Sundry Print Report

Well Name: BRUSHY DRAW 30 Well Location: T25S / R30E / SEC 30 / County or Parish/State: EDDY /

Notice of Intent

Procedure Description: **Spacing, Casing/Cement, Drilling Variance Changes **Submitted as 'Other' per AFMSSII HelpDesk Email fr/Lucinda Lewis, 03.31.2021 XTO Permian Operating, LLC requests permission to make the following changes to the original APD: No Additional Surface Disturbance Change BHL fr/2440'FNL & 330'FWL to 2440'FNL & 1025'FWL Casing/Cement design per the attached drilling program. No additional surface disturbance. XTO also requests the following variances: Approval to utilize a spudder rig to pre-set surface casing per the attached description of operations. Batch drill this well if necessary. In doing so, XTO will set each casing string and ensure that the well is cemented properly and the well is static. With floats holding, no pressure on the csg annulus, and the installation of a 10K TA cap as per recommendations, XTO will contact the BLM to skid the rig to drill the remaining wells on the pad. Once surface and intermediate strings are all completed, XTO will begin drilling the production hole on each of the wells. ONLY test broke

Wellhead diagram during offline cementing operations

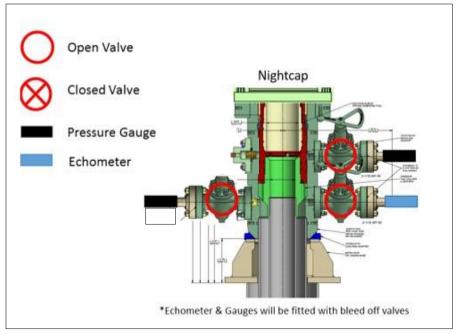
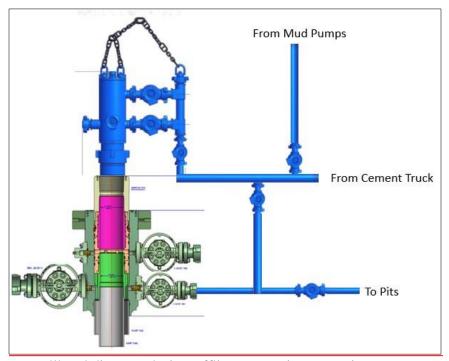
The operational sequence will be as follows. If a well control event occurs, the BLM will be contacted for approval prior to conducting offline cementing operations.

- 1. Run casing as per normal operations. While running casing, conduct negative pressure test and confirm integrity of the float equipment (float collar and shoe)
- 2. Land casing with mandrel
- 3. Fill pipe with kill weight fluid, do not circulate through floats and confirm well is static
- 4. Set annular packoff shown below and pressure test to confirm integrity of the seal. Pressure ratings of wellhead components and valves is 5,000 psi.
- 5. After confirmation of both annular barriers and internal barriers, nipple down BOP and install cap flange.
 - a. If any barrier fails to test, the BOP stack will not be nippled down until after the cement job is completed with cement 500ft above the highest formation capable of flow with kill weight mud above or after it has achieved 50-psi compressive strength if kill weight fluid cannot be verified.

- 6. Skid rig to next well on pad.
- 7. Confirm well is static before removing cap flange, flange will not be removed and offline cementing operations will not commence until well is under control. If well is not static, casing outlet valves will provide access to both the casing ID and annulus. Rig or third party pump truck will kill well prior to cementing or nippling up for further remediation.

- 10. Circulate bottoms up with cement truck
 - a. If gas is present on bottoms up, well will be shut in and returns rerouted through gas buster to handle entrained gas
 - b. Max anticipated time before circulating with cement truck is 6 hrs
- 11. Perform cement job taking returns from the annulus wellhead valve
- 12. Confirm well is static and floats are holding after cement job
- 13. Remove cement equipment, offline cement tools and install night cap with pressure gauge for monitoring.
